UNITED STATES PATENT AND TRADEMARK OFFICE

APPLICATION NO.	FILING DATE	FIRST NAMED INVENTOR	ATTORNEY DOCKET NO.	CONFIRMATION NO.
10/550,794	09/22/2005	Philip J. Barker	36-1941	4008

Office Action Summary	Application No.	Applicant(s)	
	10/550,794	BARKER ET AL.	
	Examiner	Art Unit	
	Hoang Tran	2874

DETAILED ACTION

FIG. 3

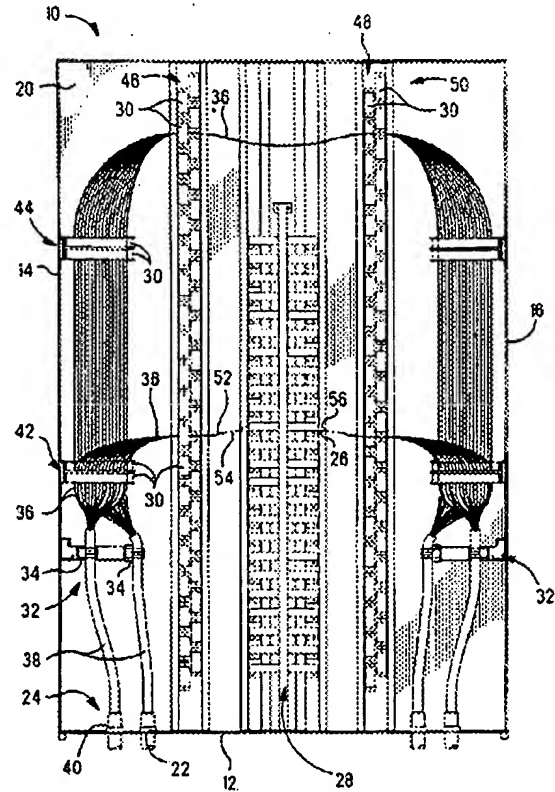
In terms of claim 1 and 33, Fasnacht teaches a flexible suite for routing optical fibers within a telecommunication switch installation, the suite comprising: a first flexibility point and a second flexibility point, the first flex (at the junction labeled '30') including a first set of conduits each of the conduits having a first end disposed in a first array (42) and a second end disposed in a second array (44); the second flexibility point including a second set of conduits, each of the conduits having a first end disposed in a third array (horizontally opposite from 2nd array '44') and a second end disposed in a fourth array (horizontally opposite from 1st array '42'); the flexibility suite being so arranged as to permit the conduit ends on the second array to be interconnected with conduit ends on the third

array by means of tubular interconnects so that, by selecting the conduits whose ends on the second and third arrays are interconnected (36), a continuous path can be formed between any conduit end in the first array and any conduit end in the fourth array (28).

As for claims 2-6, the connectors (30) for connecting the 2nd, 3rd, and 4th arrays interconnect the conduit end to the tubular interconnect by means of a double-ended connector.

As for claims 9 and 10, the 1st array is arranged side-by-side with the 4th array and the 2nd array is arranged side-by-side with the 3rd array wherein one panel holds the 1st and 2nd array and the second panel holds the 3rd and 4th array (See Fig. 3 shown above).

In terms of claims 11 and 15, the panel is a router of optical signals that is able to receive an incoming cable (fig. 3 '22').

In terms of claim 12 and 13, the incoming cable is spliced to the blow-fiber member through the splice tray (26).
